Overseas Passenger Terminal Circular Quay (Tenancy 5) Statement of Environmental Effects Section 4.55(1A) Modification

**Prepared for Jimmy's on the Mall Pty Ltd
Submitted to the Department of Planning and Environment**

**SSD 7683
Modification No. 1**

October 2018

Figure 2: Proposed Level 1 floorplan amendments (Source: Mantle Group)

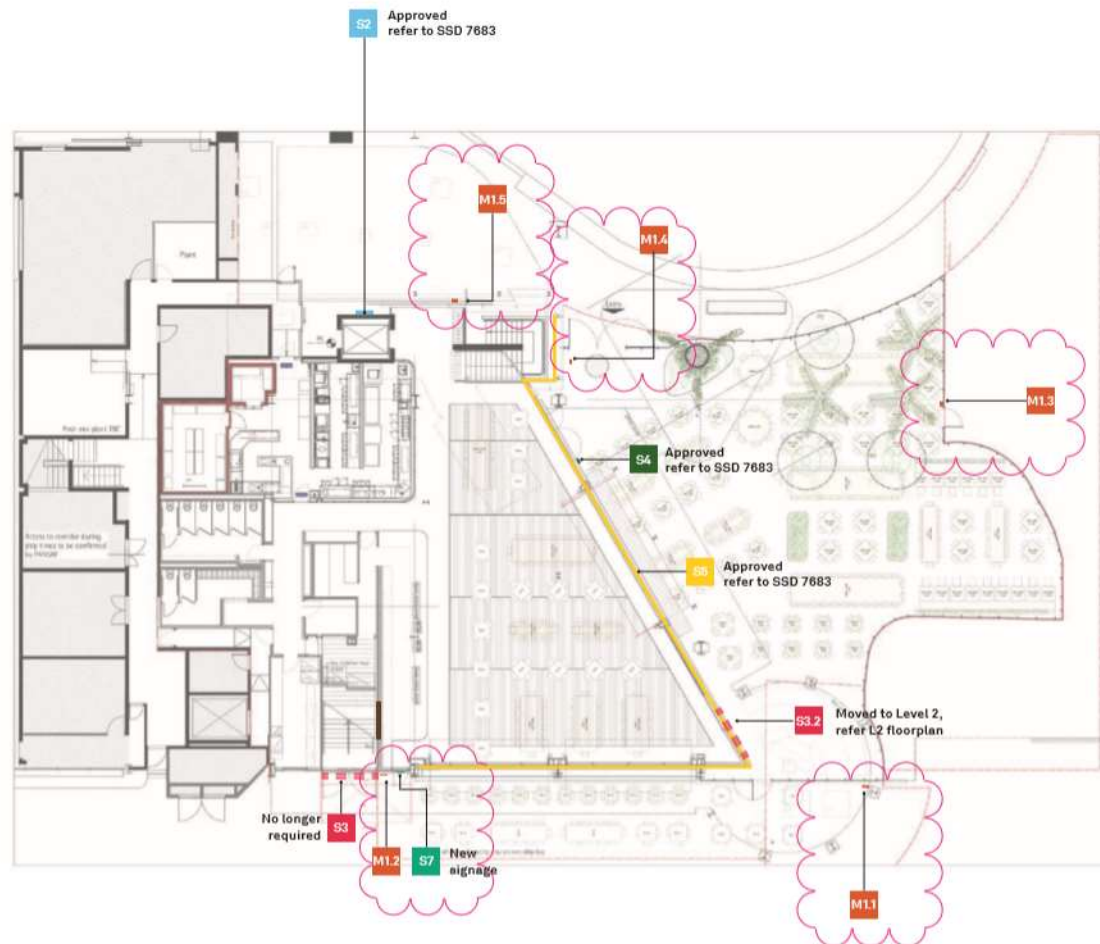
- S7** The Squire's Landing logo window vinyl
Non-illuminated – ground floor external door.
New vinyl signage – as this door is being used by customers as an entry point
- S3.2** James Squire Signature + Cross Shovels identification
moved to Level 2, refer L2 floorplan
-  **M1.1 to M1.5** Menu Stand
Freestanding menu stand with illuminated logo and menu
Modification
Five new menu stands see construction below

Figure 3: Proposed Level 2 floorplan amendments (Source: Mantle Group)

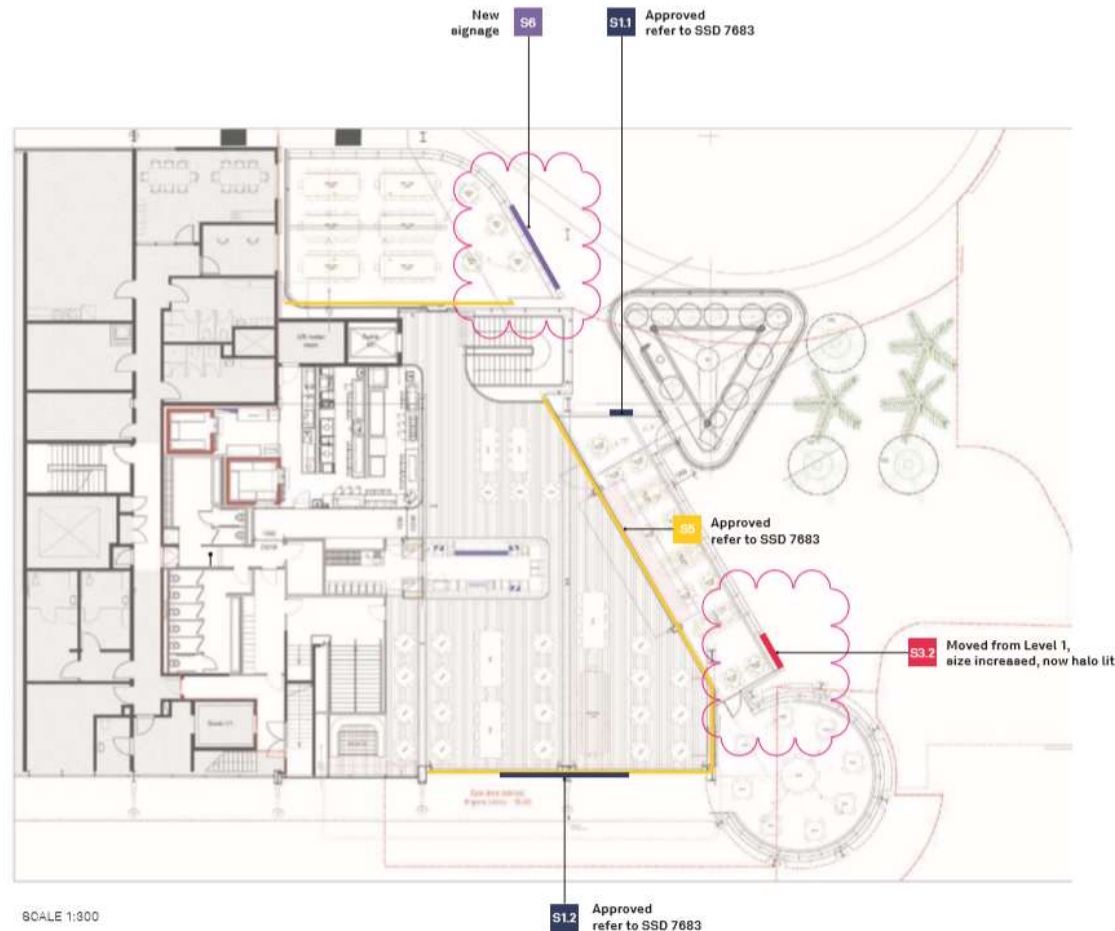
- S3.2 James Squire Signature + Cross Shovels identification**
S3.2: relocation from ground floor low level building spandrel to Level 2 awning beam. Size increases from 1285 x 220mm to 2440x380mm. Sign now halo lit.
- S6 The Squire's Landing Identification**
New sign Level 2 balcony. Sign is illuminated.

Figure 4: Example of a freestanding menu stand (Source: Mantle Group)

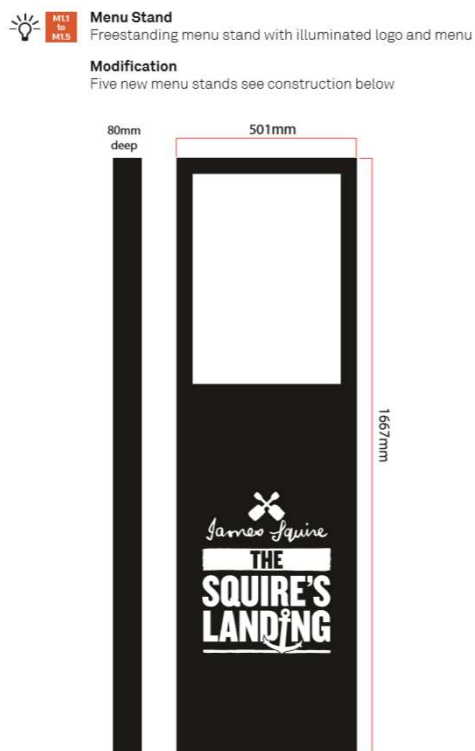
The freestanding menus are proposed to be a maximum of 1680 mm in height and 500 mm in width. Freestanding illuminated menu stands at restaurant entry points are common in the City of Sydney LGA and particularly in tourist/entertainment precincts with high levels of pedestrian activity. The dimensions of the freestanding menu are shown at **Figure 4**. A photomontage of the menu stand is shown in **Figure 5**.
